**COMMENTS OF THE GENERAL ELECTRIC COMPANY ON:  
PRELIMINARY MODEL CALIBRATION REPORT, REVISED APPENDIX B,  
MATHEMATICAL MODELING OF PCB FATE AND TRANSPORT FOR HUDSON  
RIVER PCB REASSESSMENT RI/FS: CURRENT MODELING WORK PLAN**

Figure 1. Predicted resuspension rates for a section of the Thompson Island Pool for the period January 1, 1977 to March 24, 1998.

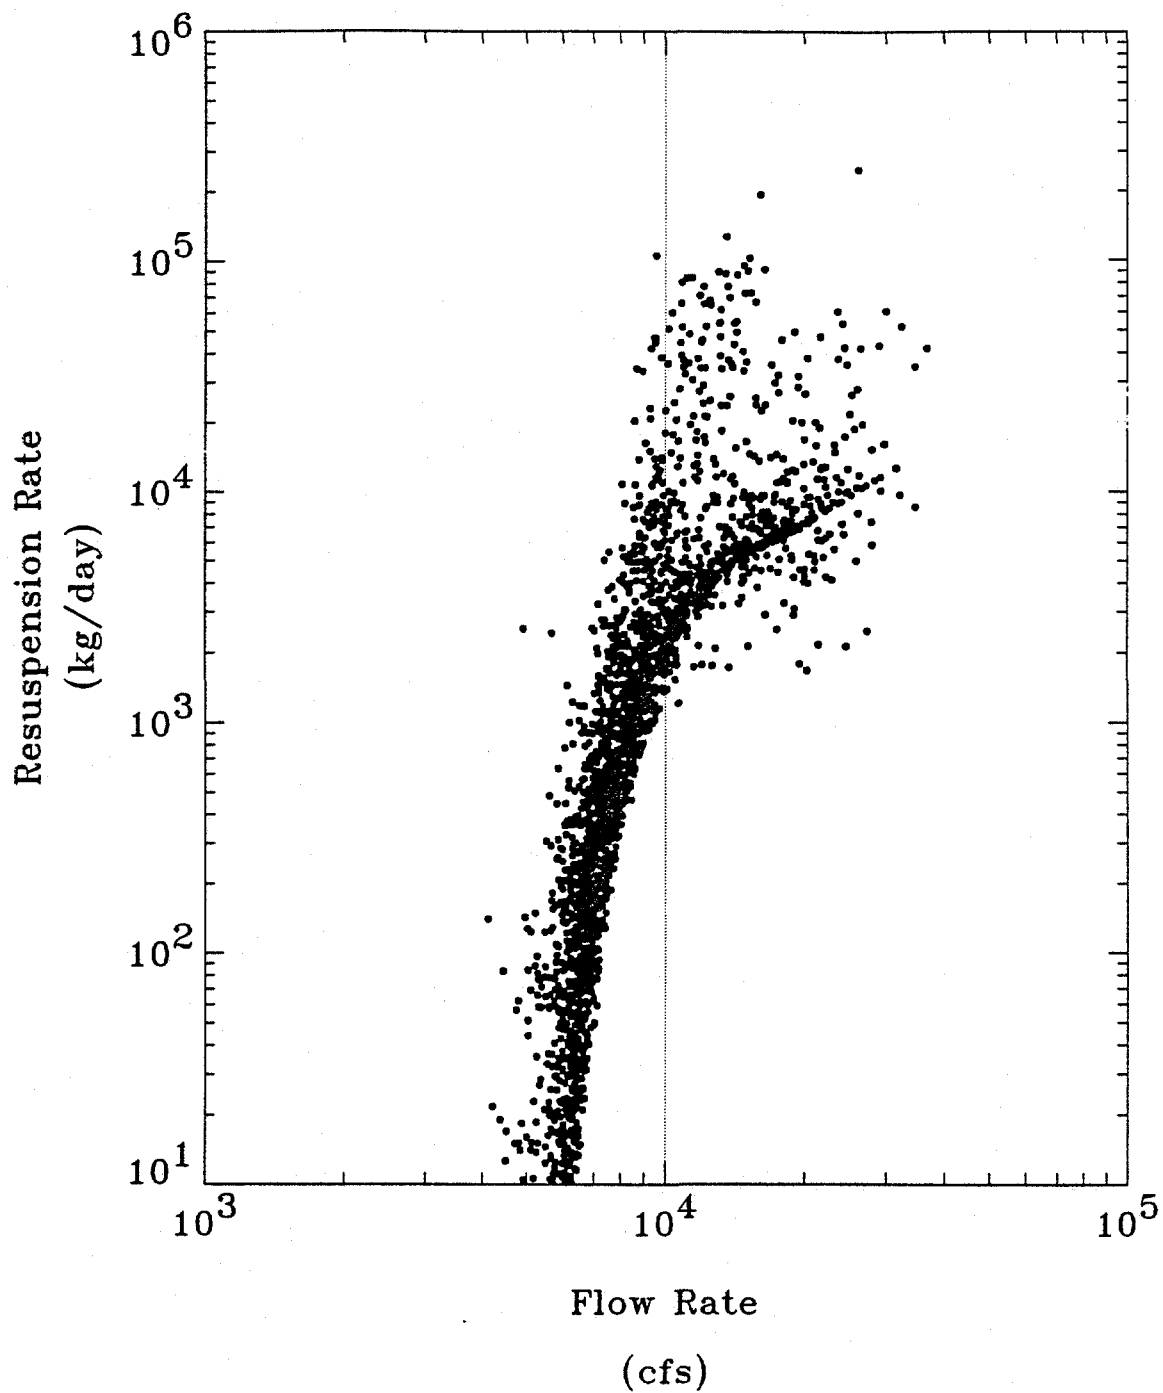
A long-term simulation, from 1977 to 1998, of sediment transport in the Thompson Island Pool was performed with the GE model. Results of the long-term simulation were analyzed to determine the effective daily-average resuspension rate and settling velocity in a section of the Thompson Island Pool. The daily-average resuspension rates and settling velocities as a function of flow rate are presented on Figures 1 and 2, respectively. The underlying structure of the resuspension and settling velocity functions is non-linear and discontinuous. Superposed on this underlying structure is a stochastic component that is caused

by temporal variations in resuspension and deposition. These results clearly demonstrate that credible development of empirical resuspension and settling velocity functions for use in EPA's HUDTOX will be very difficult, if not impossible.
